# City of Pensacola

### Agenda

Preliminary Plat Grove Park Townhomes

**MEMORANDUM**

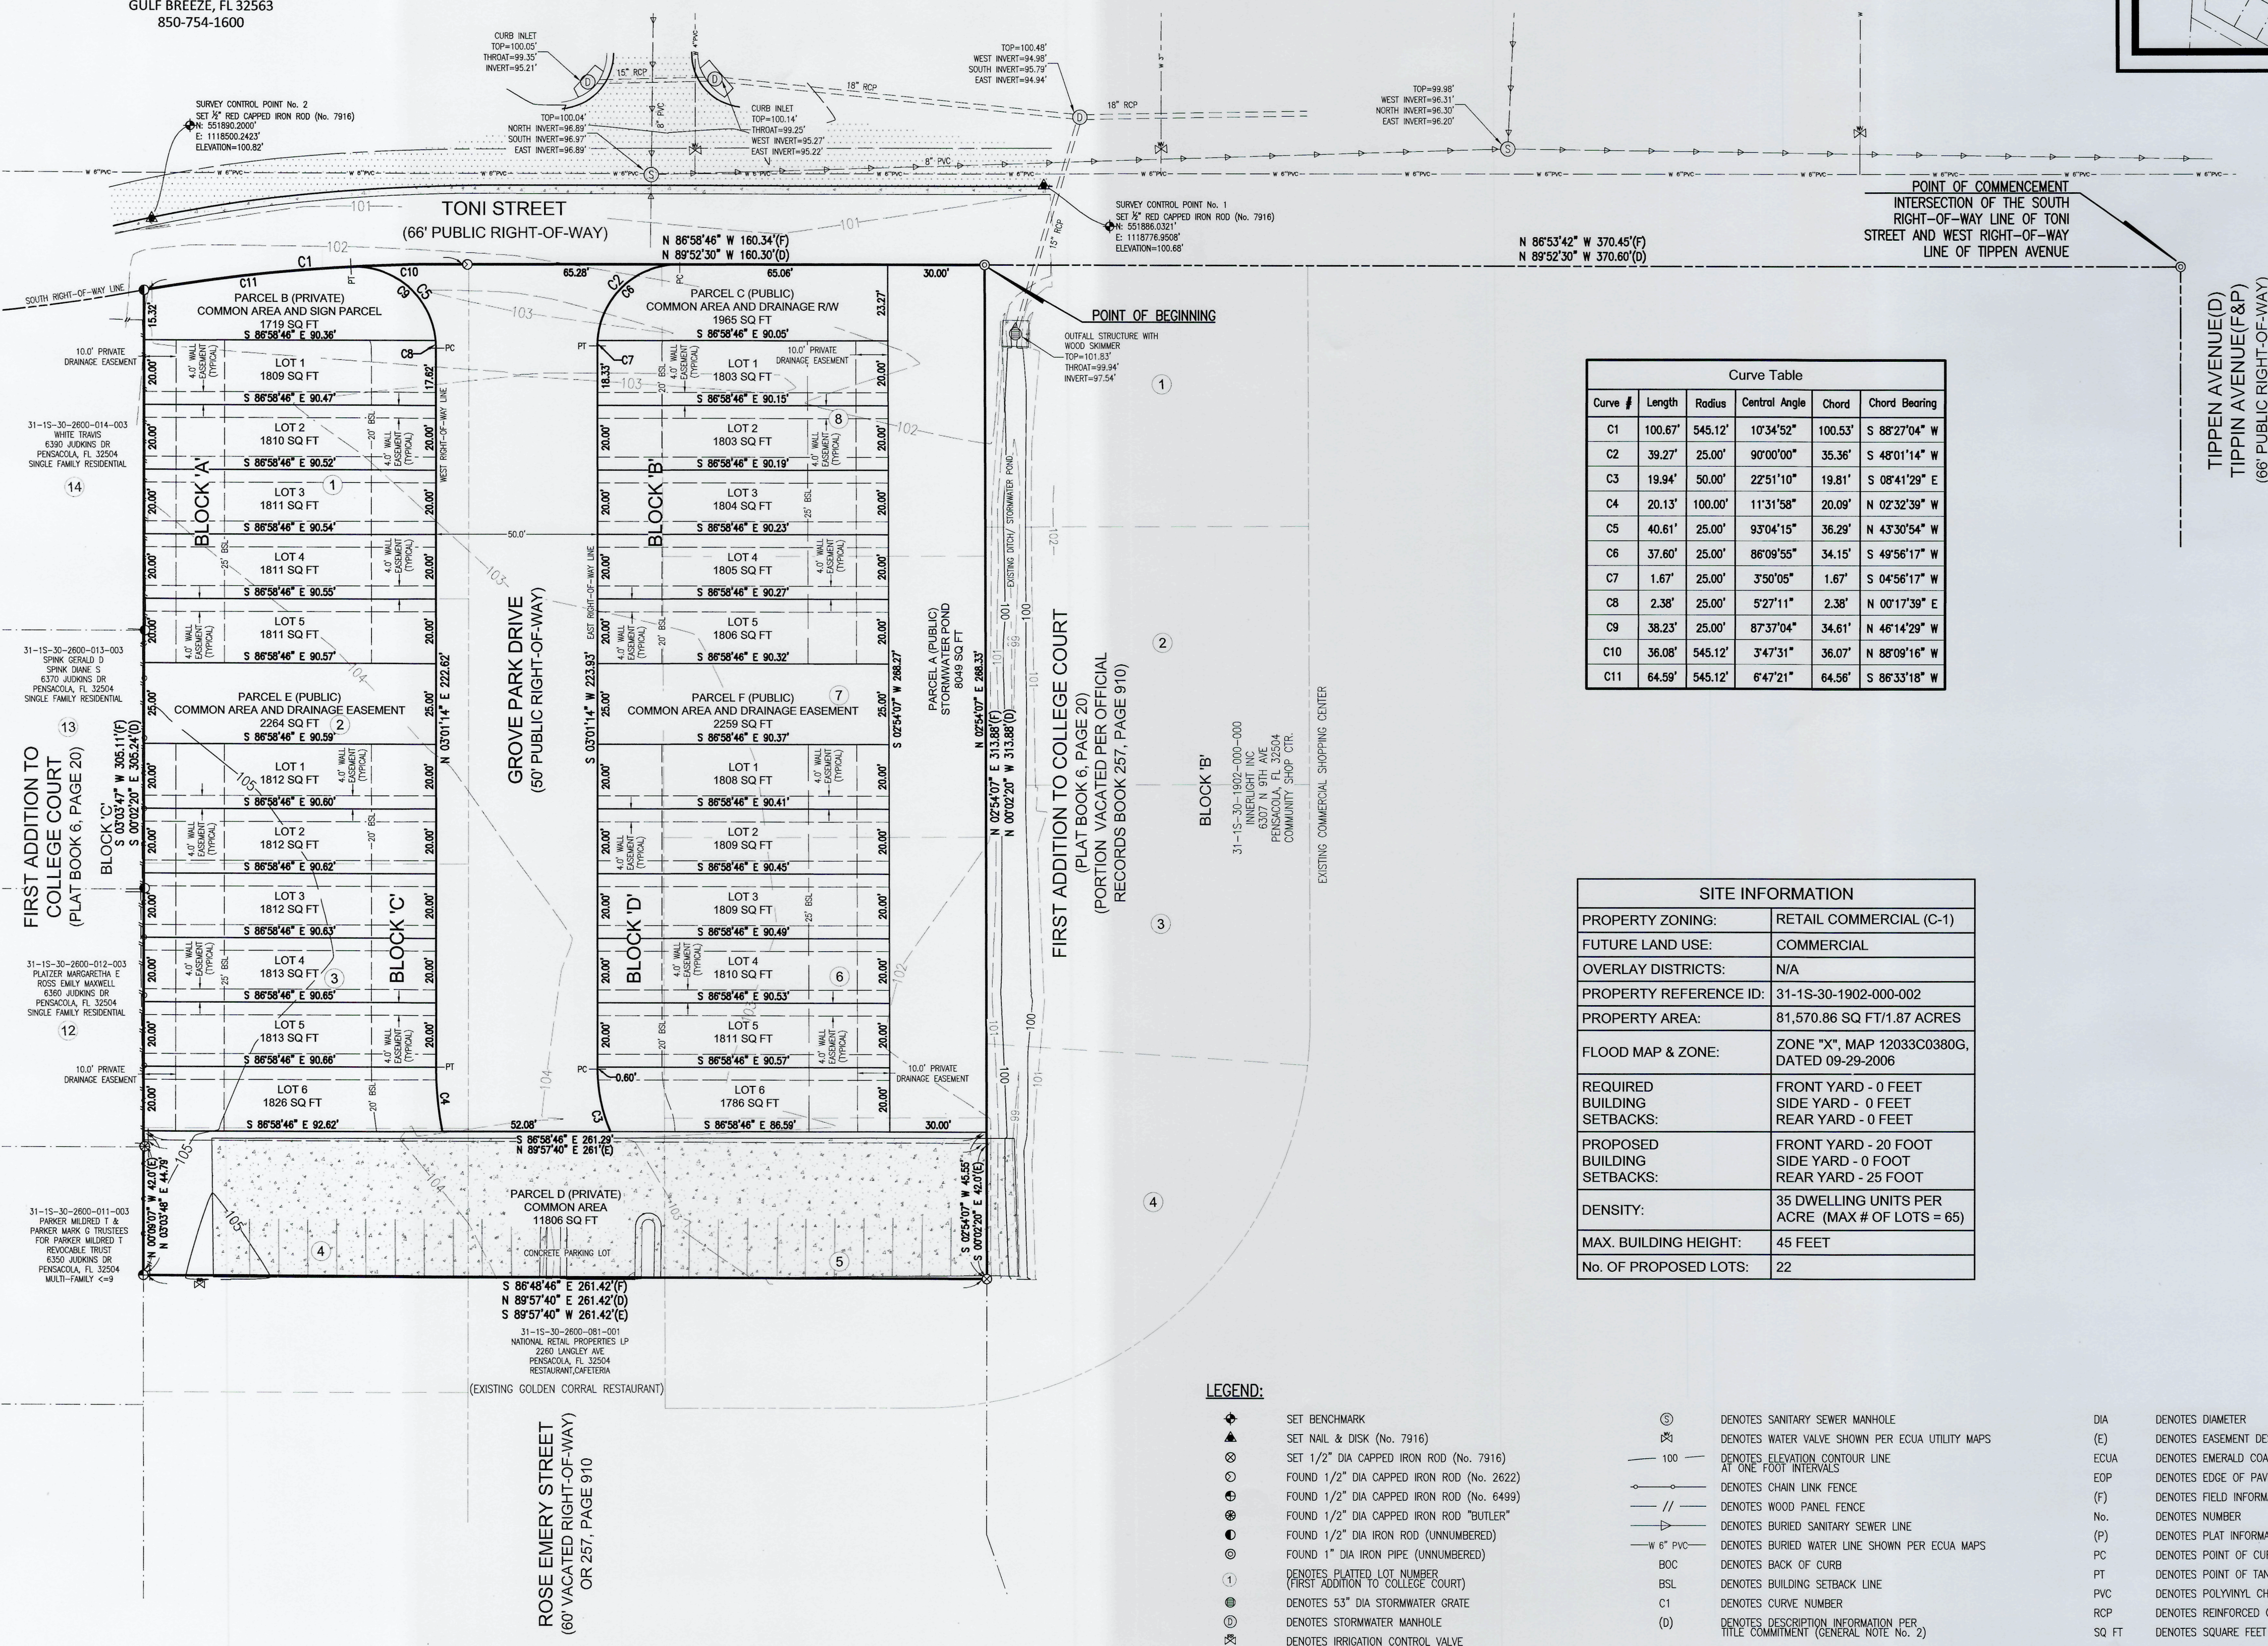
1. Add tie line information per LDC Section 12-7-8 (m)
2. Confirm capped iron rod on the northern boundary of the parcel
3. Add typical lot size per LDC Section 12-7-8 (k)
4. Property Appraiser indicates Parcel D has an existing easement.

Engineering notes that as part of the preliminary plat approval the applicant shall provide a master drainage plan at a scale not smaller than one-inch equals 200 feet per Section 12-7-3.

- 1) not in compliance with FS Chapter 177.041(1), feel free to call me and discuss options
- 2) see LDC 12-7-8e easement information needed
- 3) add typical lot size per LDC 12-7-8k
- 4) add tie line info per LDC 12-7-8m
